9835 and 9837

UNIVERSAL COUNTER TIMERS 9835 & 9837AMENDMENTOverall Circuit Diagram. Figure 4.6

Fig. 4-5

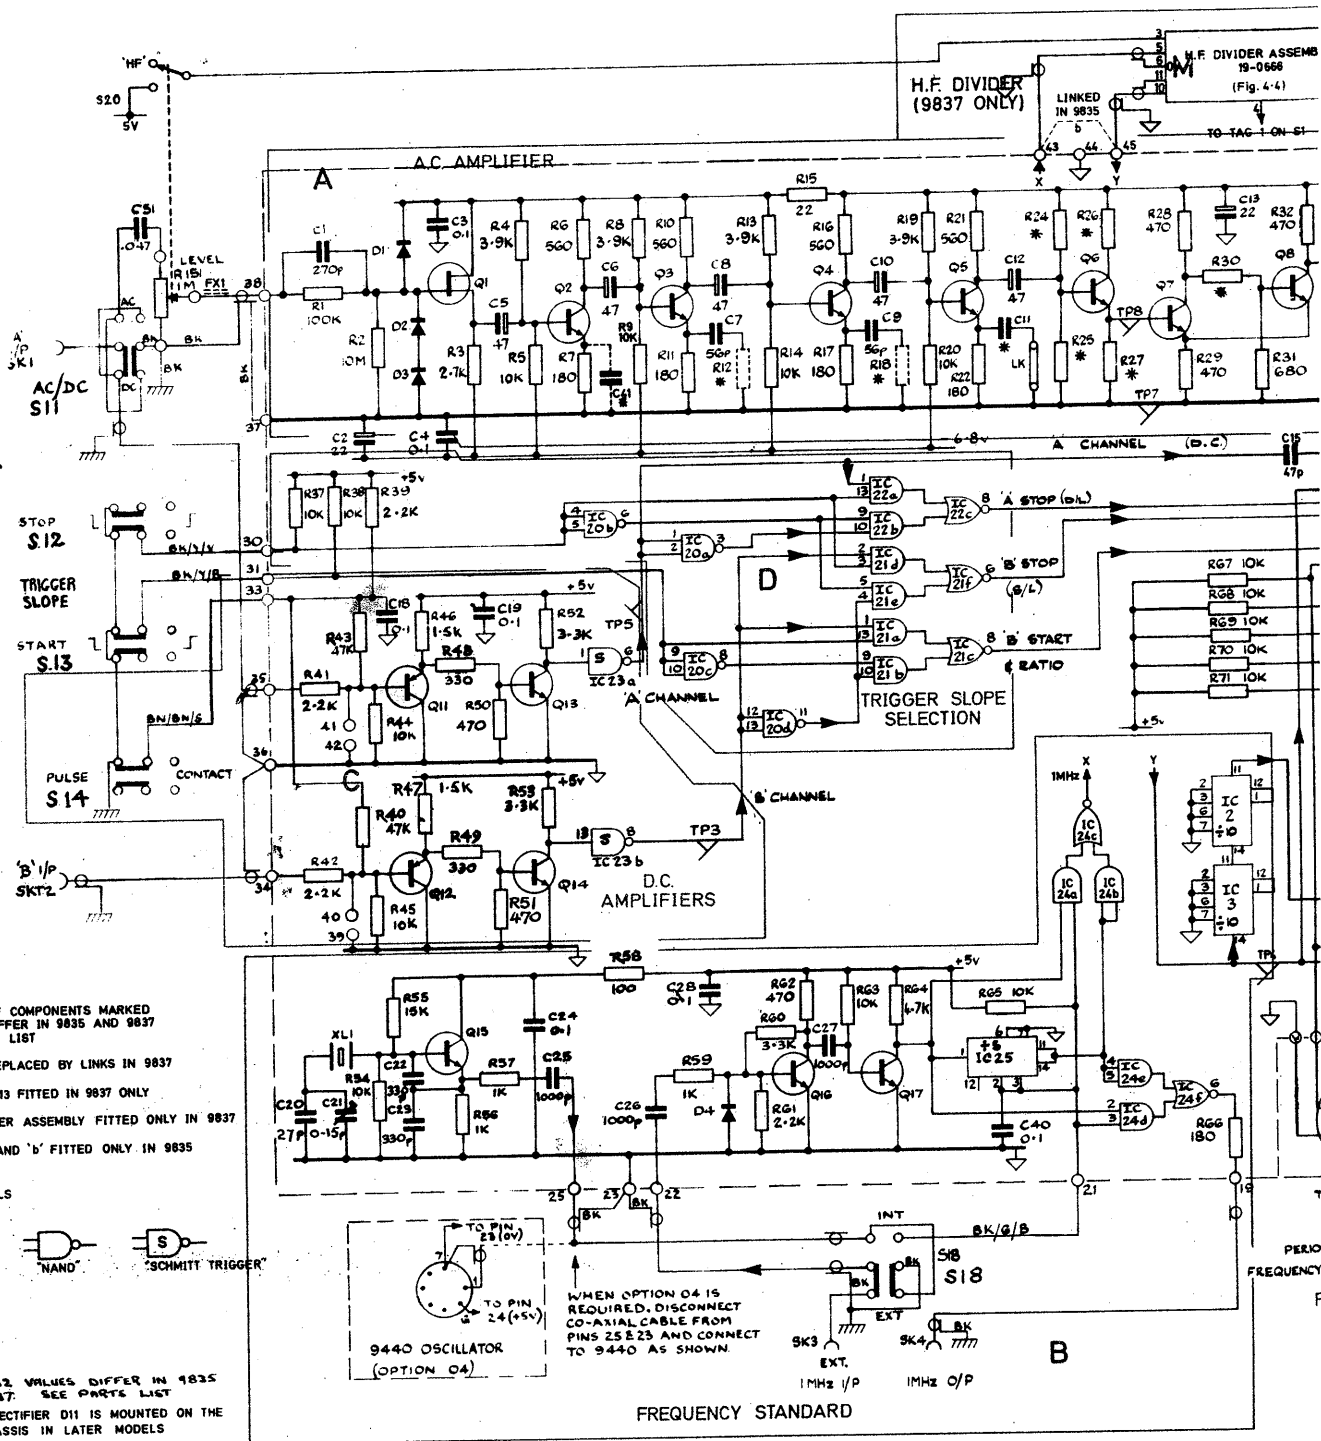
1. In Area 'K' the value of capacitor C32 should be changed from 10μ to 15μ .
The details in the Parts List (page 6-5) are correct.
2. In Area 'L' insert new capacitor C38, 1.0μ , between the lower end of fuse F31 and 0V rail.
The details are given in the Parts List (page 6-5).
